PROPOSED IMPROVEMENT
BRIDGE PROJECT

ROUTE NO. T.H. 4 (CLASS 2), BRIDGE NO. 12

PROJECT DESCRIPTION: INSTALLATION OF A NEW FLOOR SYSTEM AND DECK, REHABILITATION OF EXISTING TRUSSES AND SUBSTRUCTURE AND ROADWAY APPROACHES

PROJECT CAVENDISH BHO 1442(22)
SHEET 1 OF 34 SHEETS

EXPANSION PREFORMED FABRIC BEARING
(4) REQ'D @ ABUT. 2, STRINGER

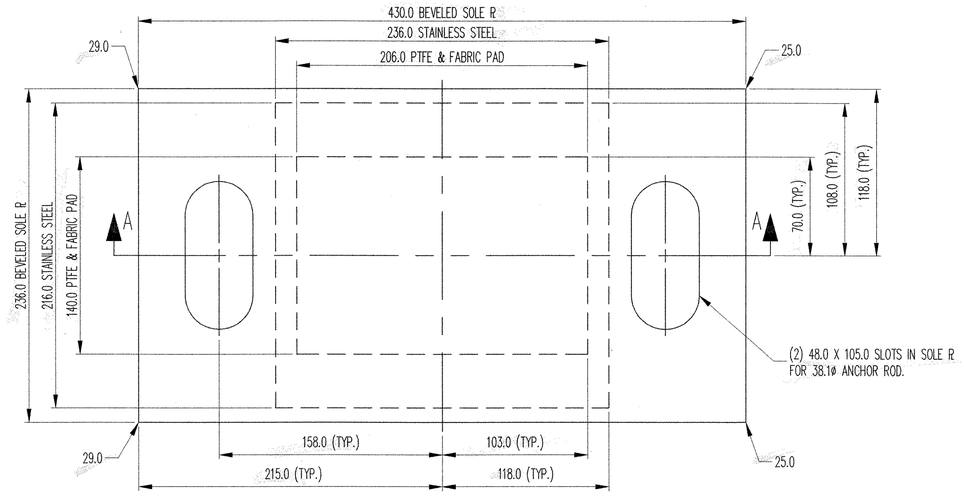
PLEASE PROVIDE. WILL BE NEEDED FOR TESTING.

EXPANSION PREFORMED FABRIC BEARING
1 (2) REQ'D @ ABUT. 2, TRUSS UPSTREAM

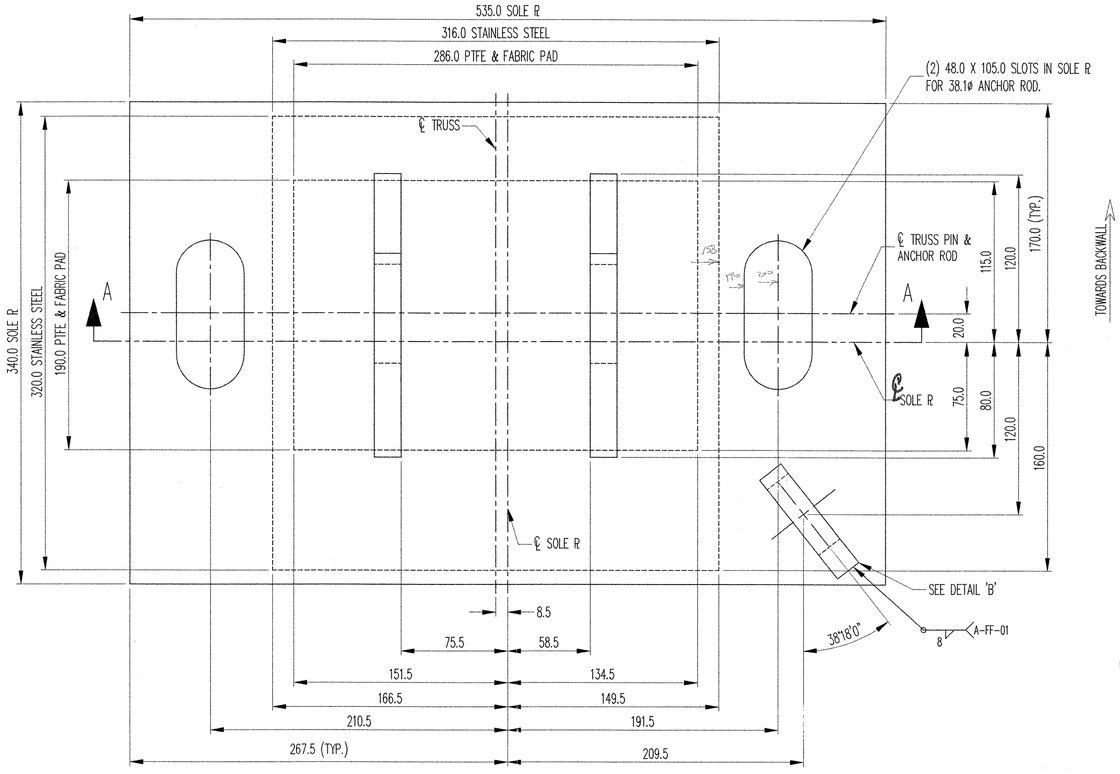
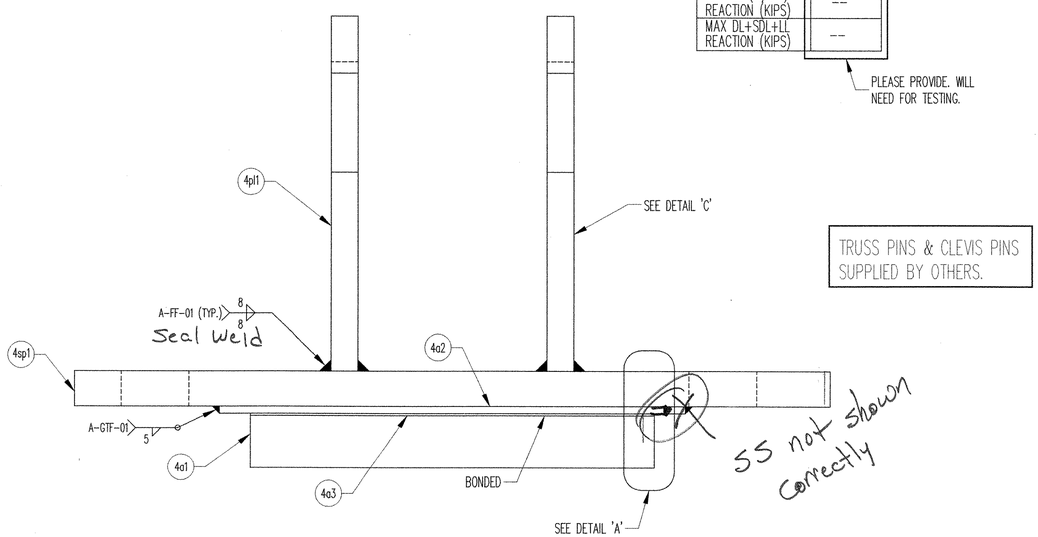
PLEASE PROVIDE. WILL NEED FOR TESTING.

SS not shown correctly

FIXED PREFORMED FABRIC BEARING
(1) REQ'D @ ABUT. 1, TRUSS UPSTREAM

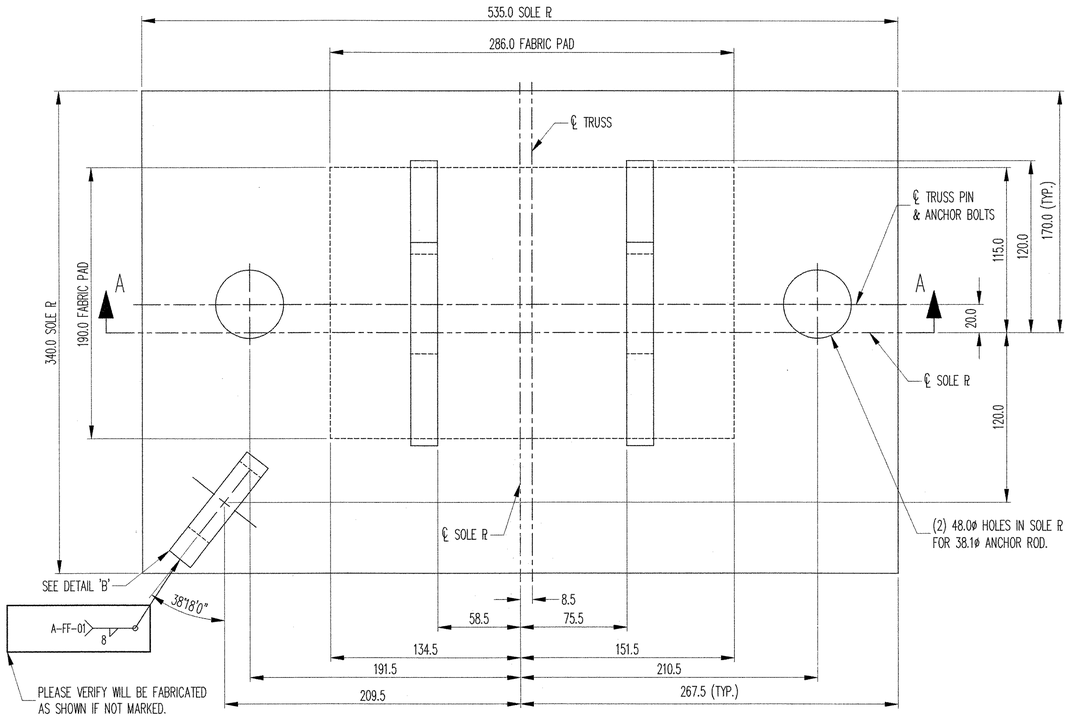
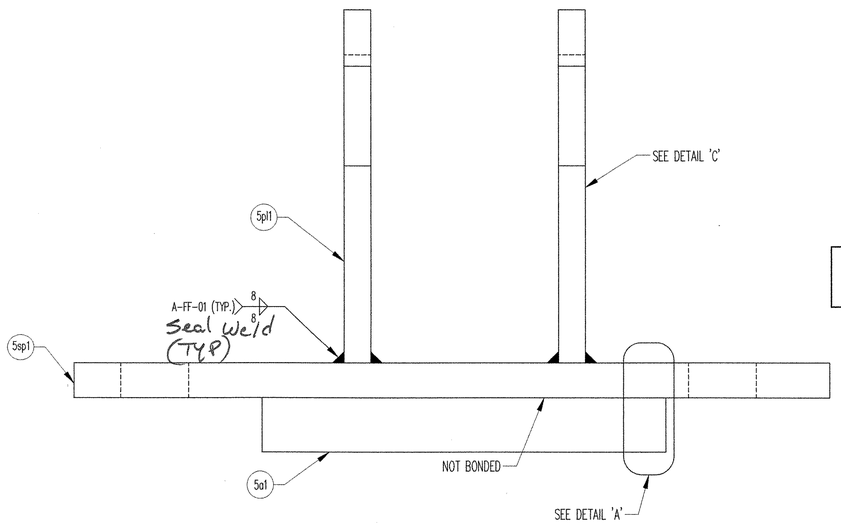
PLEASE VERIFY THAT THIS BEARING IS SHOWN AS REQUIRED BY NOTE 1 IN CONTRACT PLANS. WILL BE FABRICATED AS SHOWN IF NOT MARKED.

EXPANSION PREFORMED FABRIC BEARING
1 ~~(2)~~ REQ'D @ ABUT. 2, TRUSS DOWNSTREAM

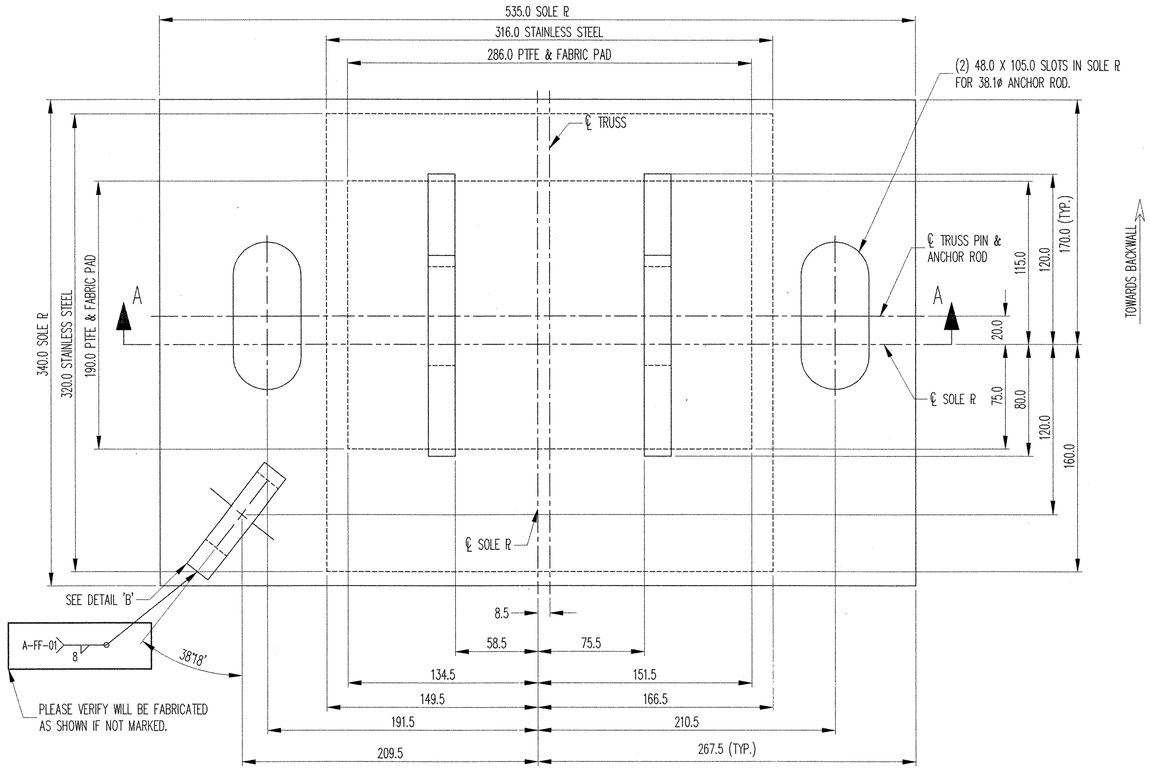
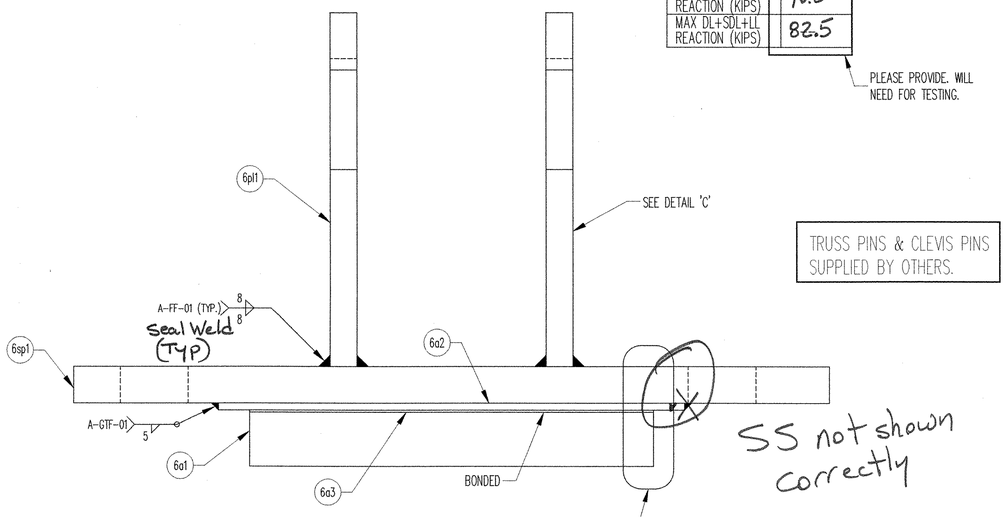
PLEASE PROVIDE. WILL NEED FOR TESTING.

SS not shown correctly

PLEASE VERIFY THAT THIS BEARING IS SHOWN AS REQUIRED BY NOTE 1 IN CONTRACT PLANS. WILL BE FABRICATED AS SHOWN IF NOT MARKED.

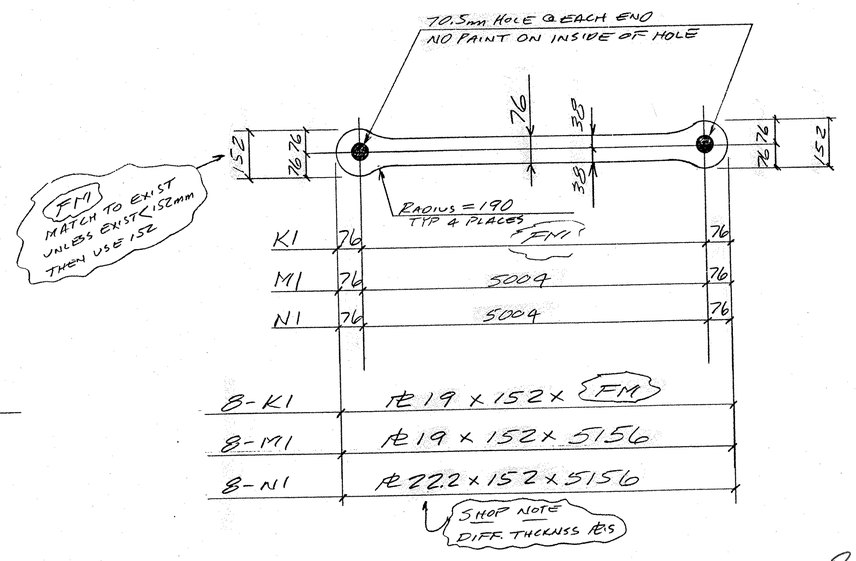
Channels & Bot. Batter ℄'s will be totally replaced for members L0-U1 & U5-L6 on both trusses

5-PLATES - E3

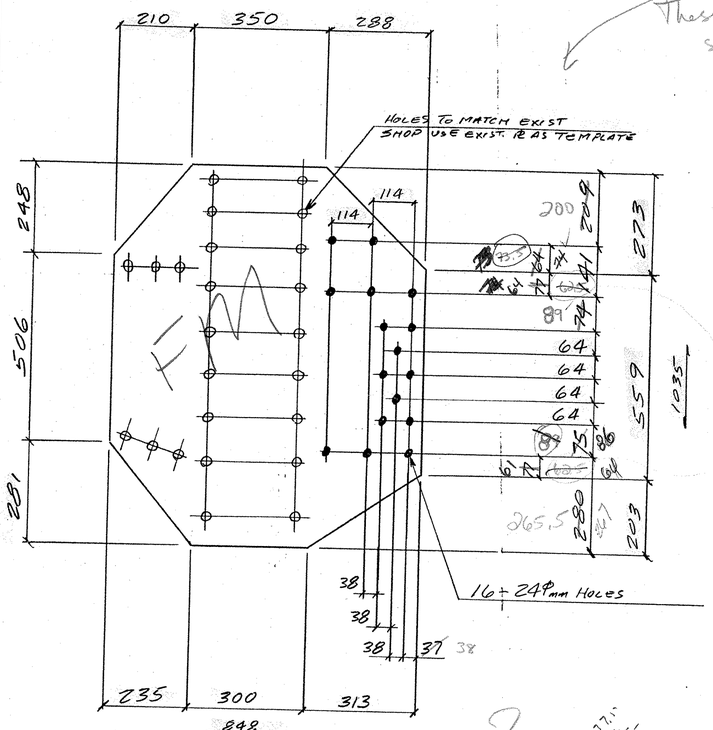
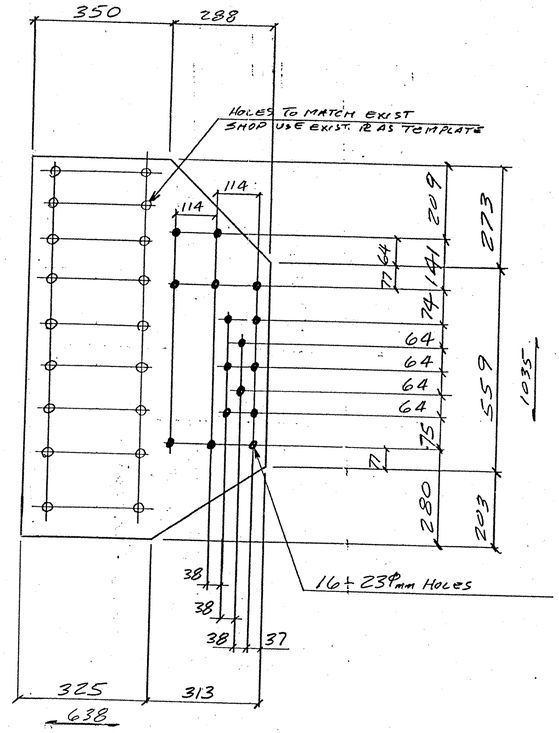
These need some changes

FM? In plans it says adjust as needed for clearance

(25) Deck Panels

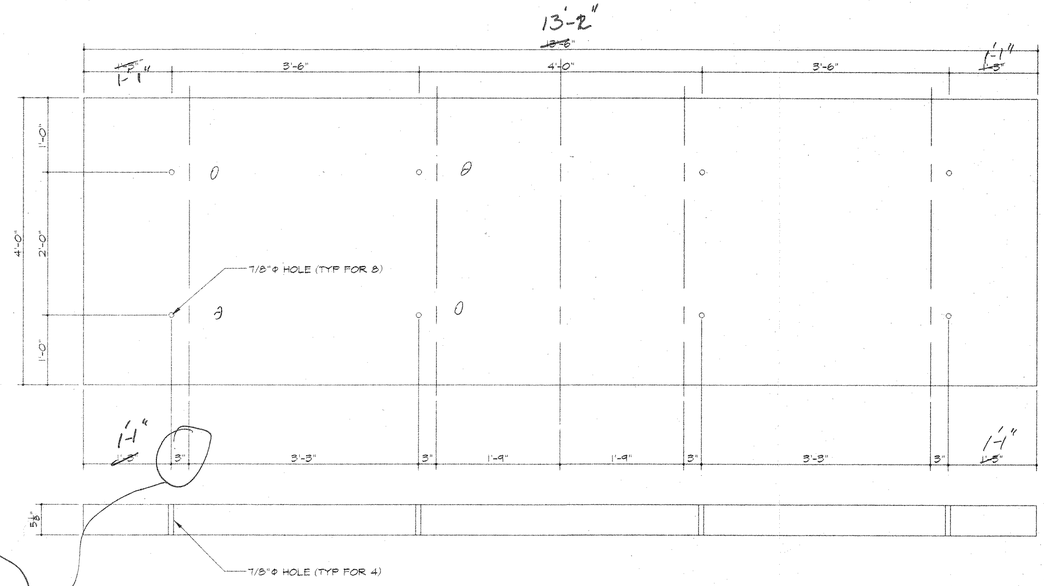
3/8 2 3/8 was correct Talked of fabricator on 4-20-04
